SUBJECT: BRAIDWOOD STATION, UNITS 1 AND 2—NRC INITIAL LICENSE
EXAMINATION REPORT 05000456/2019301 AND 05000457/2019301

POST-EXAMINATION COMMENT, EVALUATION, AND RESOLUTION

Question #10

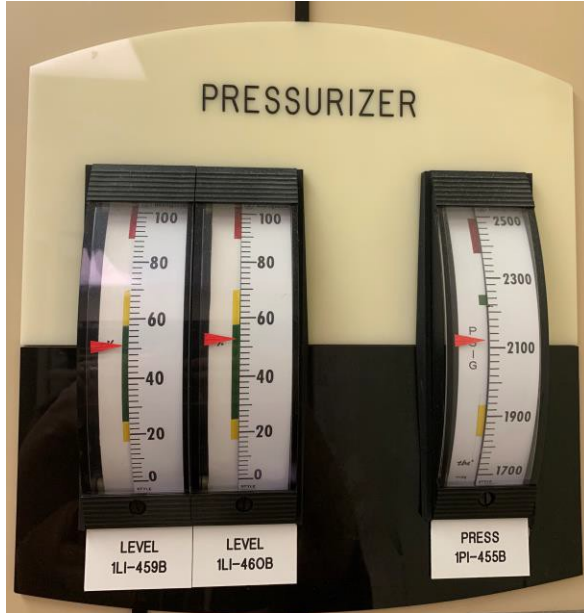
Q#10 The question is not bound by time and therefore could be understood to mean first vice all actions the crew will take.

Q#10 – No change required. The question did not require bounding by time in the stem since answer B was designated by “ONLY”.

The NRC notes that, in accordance with NUREG-1021 ES-403, Section D.1.a, and NUREG-1021 Appendix E, Section B.7, no questions were posed by any applicants during the examination regarding Question #10. The NRC also notes that, in accordance with NUREG-1021 ES-403, Section D.3.a and NUREG-1021 ES-501, Section D.2.d, the facility's performance analysis indicates that only 25 percent of applicants answered Question #10 incorrectly.

Although the applicant contends that the question stem does not specify a timeframe, this is irrelevant since the use of the word “only” in the answer/distractor choices logically results in “D” being the only correct answer to the question. Therefore, the NRC concludes that no change should be made to the key regarding this exam question. This is also consistent with the recommendation of the facility regarding this specific applicant comment.

BwCB-1 Figure 31, Pressurizer Level 462 Cold Calibration, Revision 1

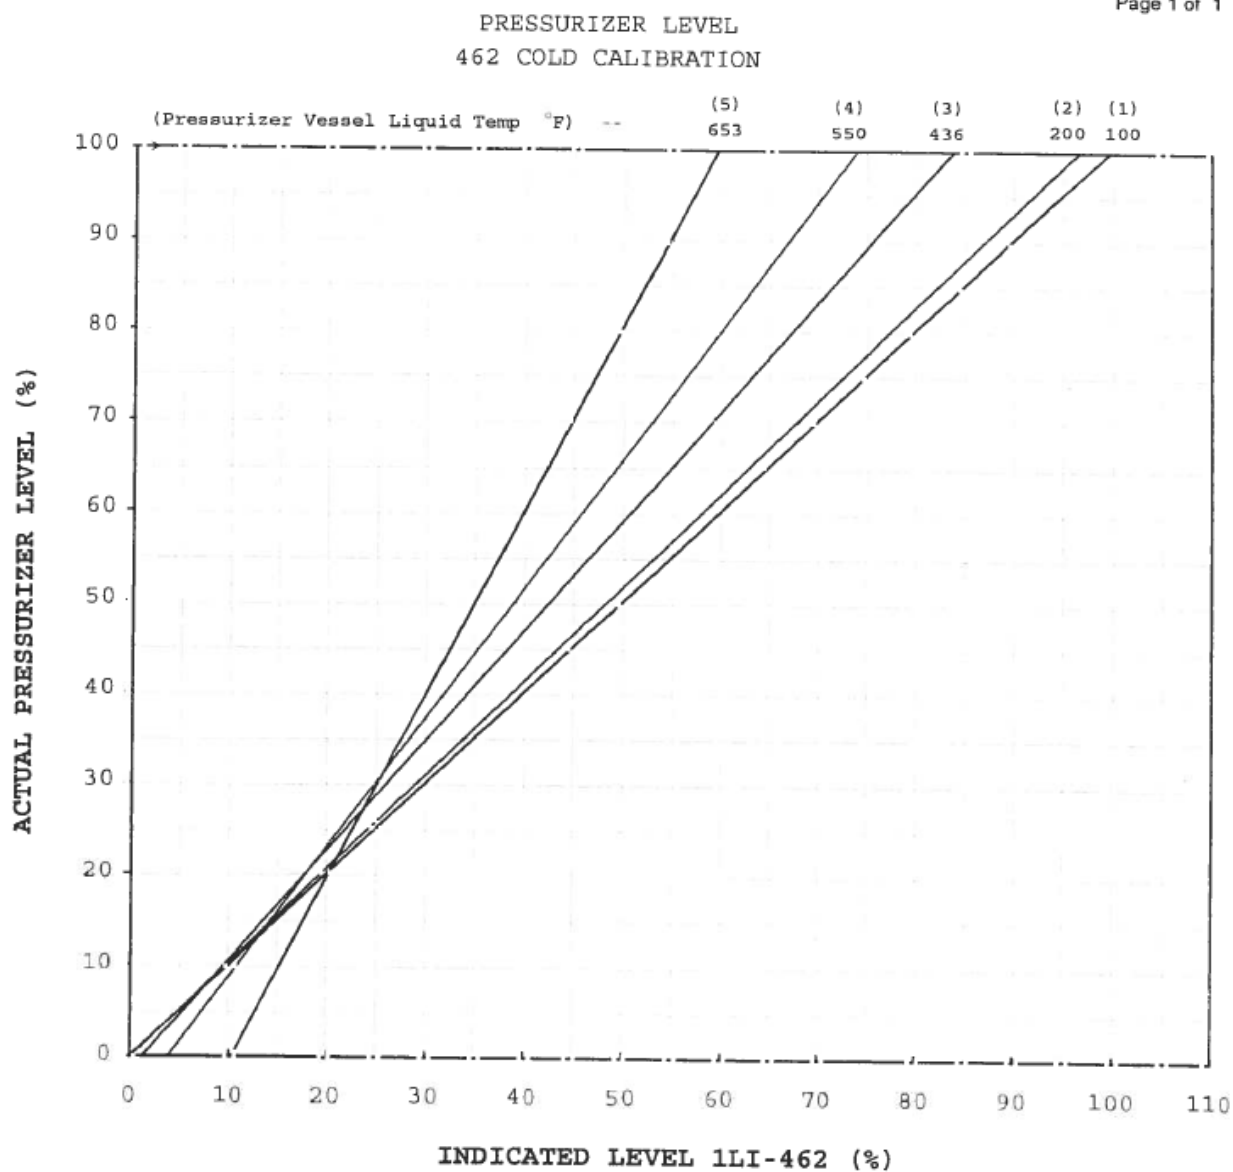
Q#24 Distractors B & D did not contain the entire name of the BwCB reference (BwCB-1 FIG. 31, Pressurizer Level 462 Cold Calibration). This made the question confusing to the applicants since the level instrument in the stem will have accuracy affected during the cooldown.

Q#24 – Accept B as a second correct answer. 1BWOA PRI-5 will direct a plant cooldown and depressurization if desired by the shift manager at step 23. This creates a situation where, during the cooldown, the accuracy of the hot calibrated pressurizer level instrumentation (1LI-459B & 1LI-460B as shown in the stem) could be inaccurate. Since the full title of the BwCB was not given and the figure was not provided as a reference, the question confused the applicant due to an unintended typographical error. Therefore, the applicant did not have the required information to determine the BwCB-1 Fig. 31 would not have been applicable.

The NRC notes that, in accordance with NUREG-1021 ES-403, Section D.1.a, and NUREG-1021 Appendix E, Section B.7, no questions were posed by any applicants during the examination regarding Question #24. The NRC also notes that, in accordance with NUREG-1021 ES-403, Section D.3.a and NUREG-1021 ES-501, Section D.2.d, the facility's performance analysis indicates that only 37.5 percent of applicants answered Question #24 incorrectly.

Regardless of any reference made to "BwCB-1 FIGURE 31" in the answer/distractor combinations, the key wording in the available choices consists of "WILL require temperature correction" or "will NOT require temperature correction." 1BwGP 100-5 discusses correcting only the 1LI-462 (the cold calibrated instrument) level indication based upon pressurizer temperature conditions. Thus, including any reference to BwCB-1 FIGURE 31 was ultimately unnecessary, since only the understanding that 1LI-462 requires temperature correction during a cooldown (as specified in 1BwGP 100-5) was necessary to select between the options presented by the second half of the two-part question. Therefore, the NRC concludes that no change should be made to the key regarding this exam question.

Question #37

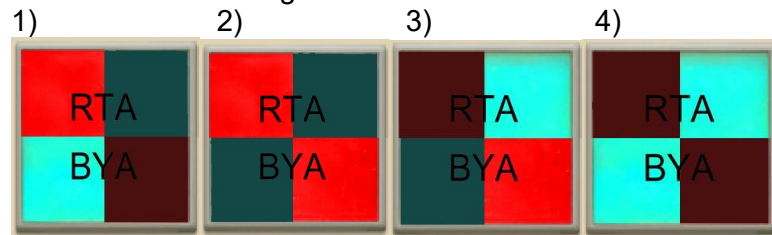
Q#37 The stem picture quality on the printed version of the exam caused confusion as to which lights were lit and which lights were out.

Q#37 – No change required. The exam was adequate to determine which indicating lights were lit. If this was unclear at the time, the examinee could have asked for clarification.

The NRC notes that, in accordance with NUREG-1021 ES-403, Section D.1.a, and NUREG-1021 Appendix E, Section B.7, no questions were posed by any applicants during the examination regarding Question #37. The NRC also notes that, in accordance with NUREG-1021 ES-403, Section D.3.a and NUREG-1021 ES-501, Section D.2.d, the facility's performance analysis indicates that only 12.5 percent of applicants answered Question #37 incorrectly.

The applicant contends that their ability to answer this question was negatively affected by the print quality of the graphics on the administered examination. To validate this, the NRC was provided the actual page from the applicant's examination containing the graphics in question. A review of this page indicated the print quality was satisfactory and that the colors used in the graphics provided sufficient fidelity to those that would appear in the actual plant to allow for accurate interpretation by applicants. As previously noted, no clarification was requested by any applicant during the exam for this question and, furthermore, the facility's performance analysis indicates that only a single applicant answered this question incorrectly. Therefore, the NRC concludes that no change should be made to the key regarding this exam question. This is also consistent with the recommendation of the facility regarding this specific applicant comment.
